**PROPOSED SEWAGE DISPOSAL SYSTEM**

TO SETZLE A PROPOSED FOUR-BEDROOM DWELLING AND A PROPOSED ONE-BEDROOM GARAGE

HARTSHORN ROAD, MASSACHUSETTS, ASSESSOR PLOT 20-38

DATE: NOVEMBER 7, 2002 SCALE: AS NOTED

**PLOT PLAN**  
 SCALE: 1" = 40'  
 LOT AREA: 1.91 ACRES

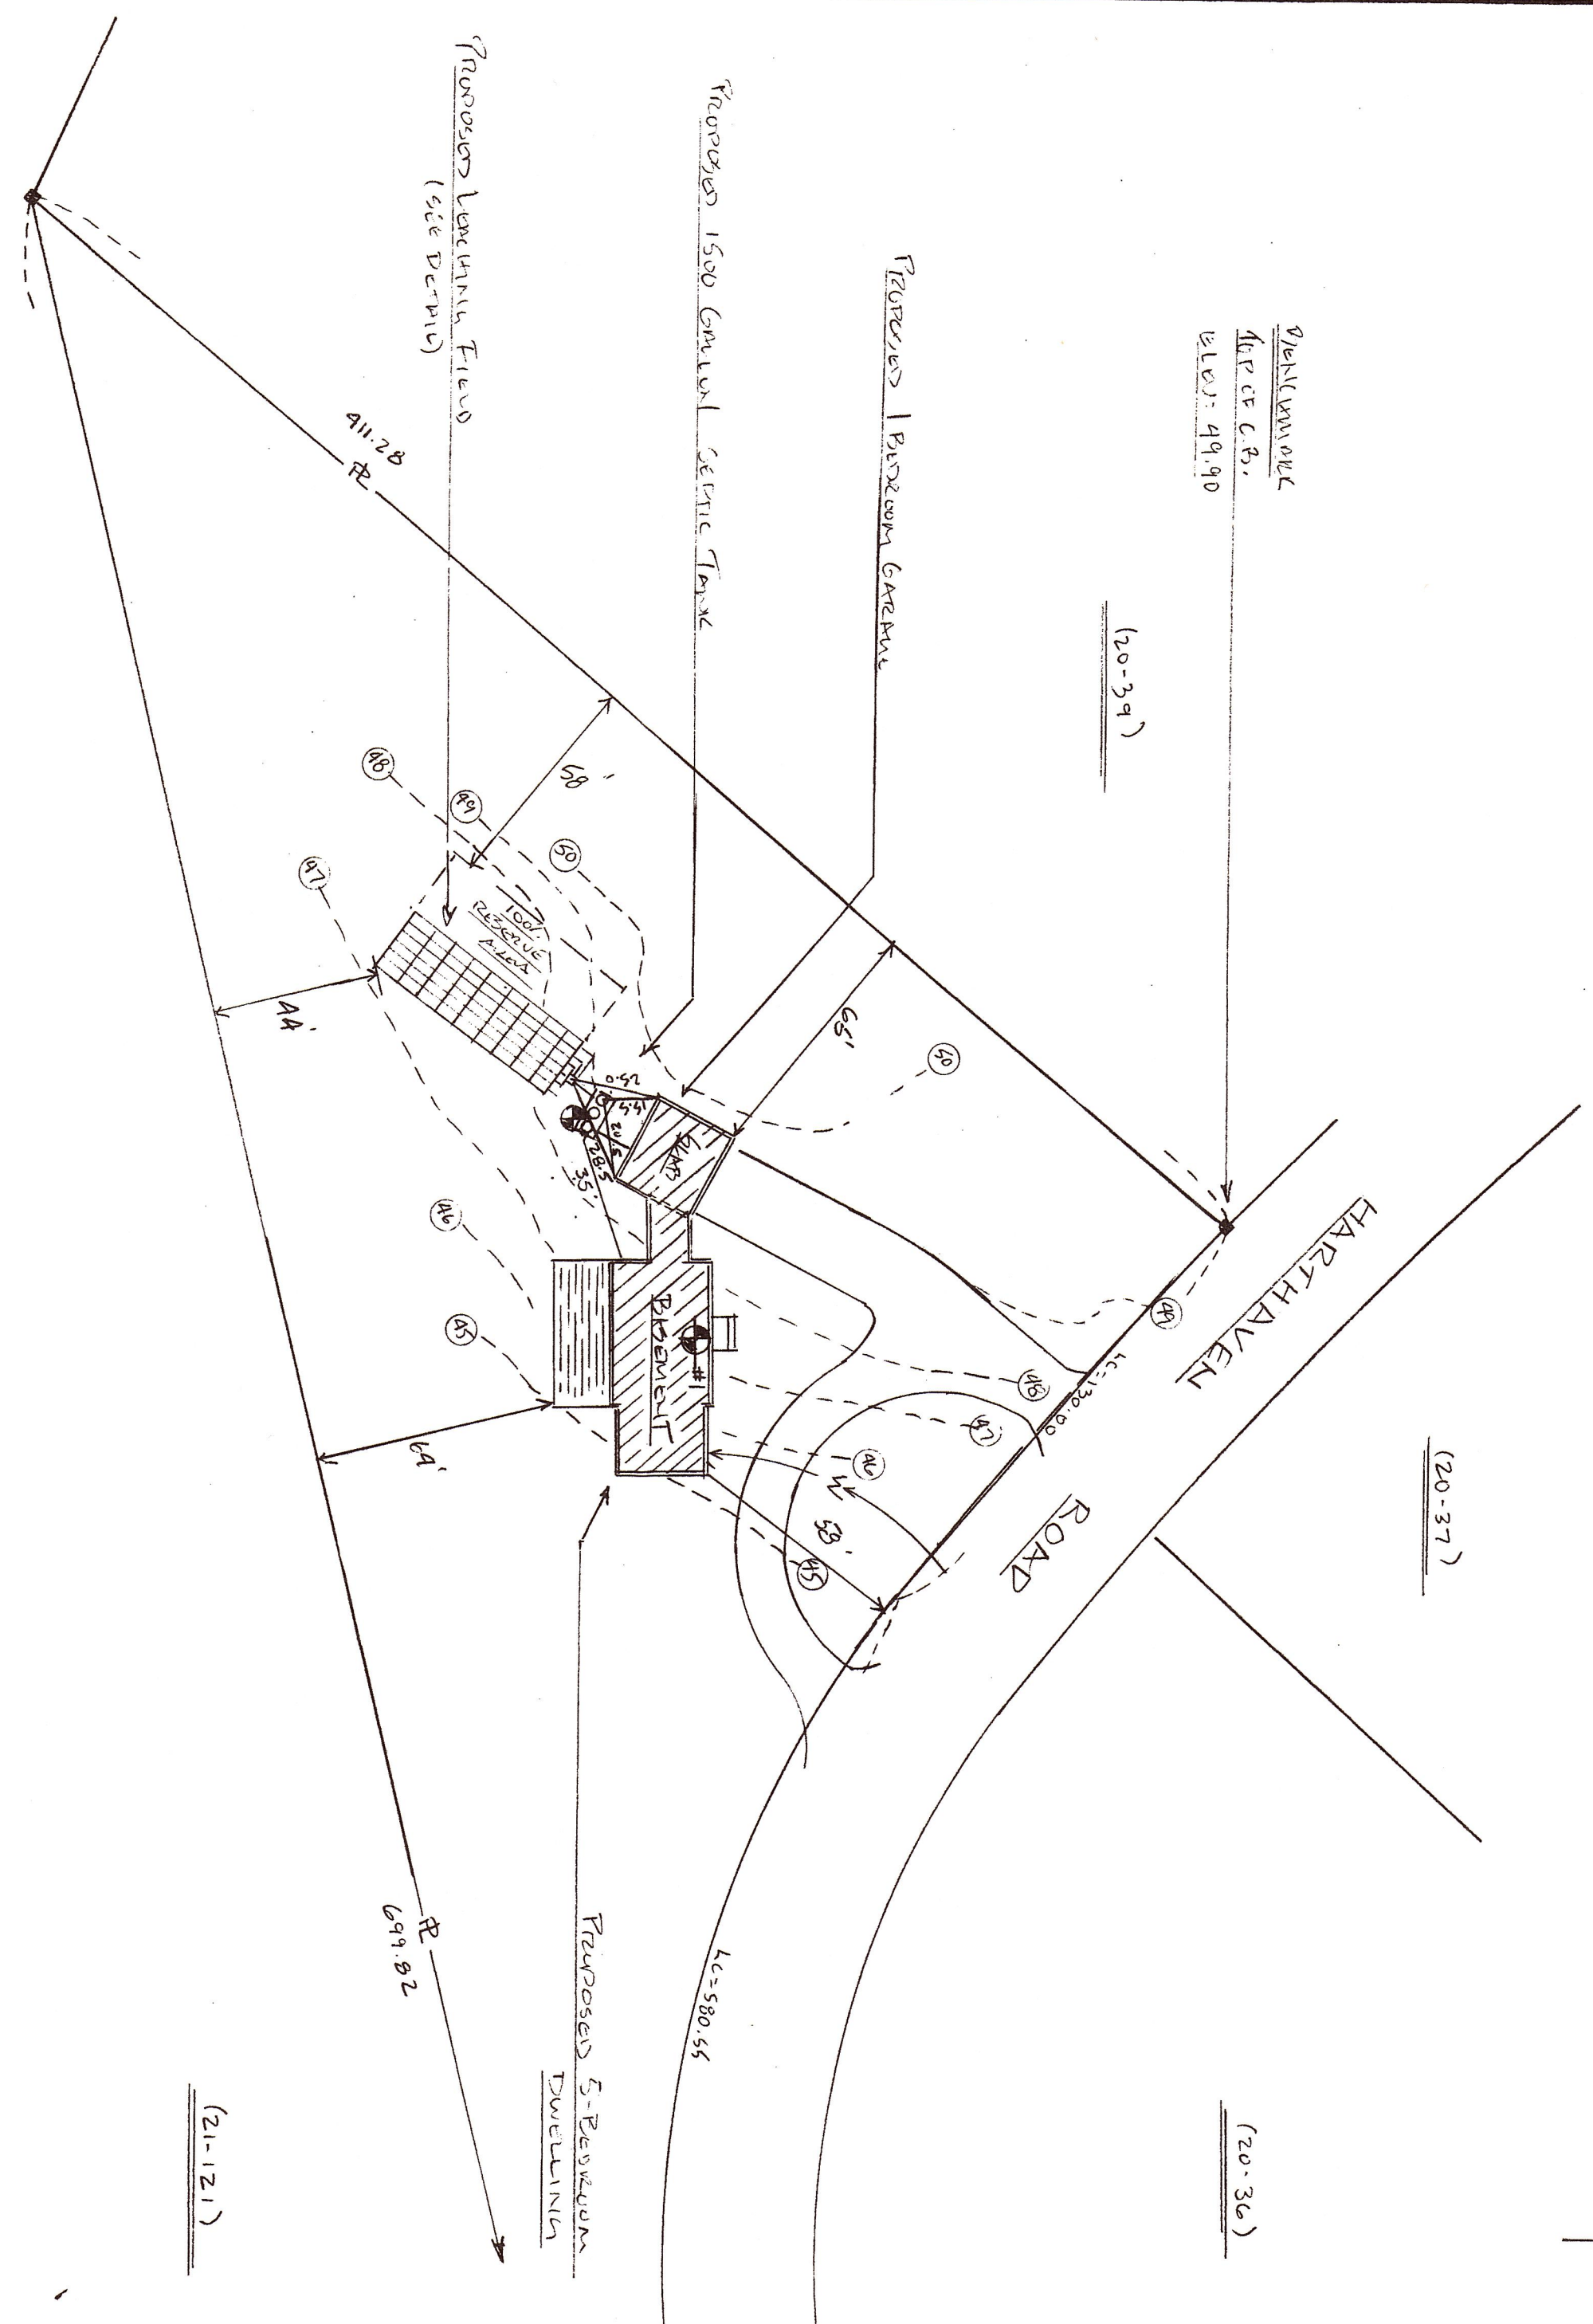
*Handwritten notes:*  
 A. This Water Waste Field is within 100' of the proposed Central Field  
 To Classify within Zone II of the Farm Neck Environmental Well
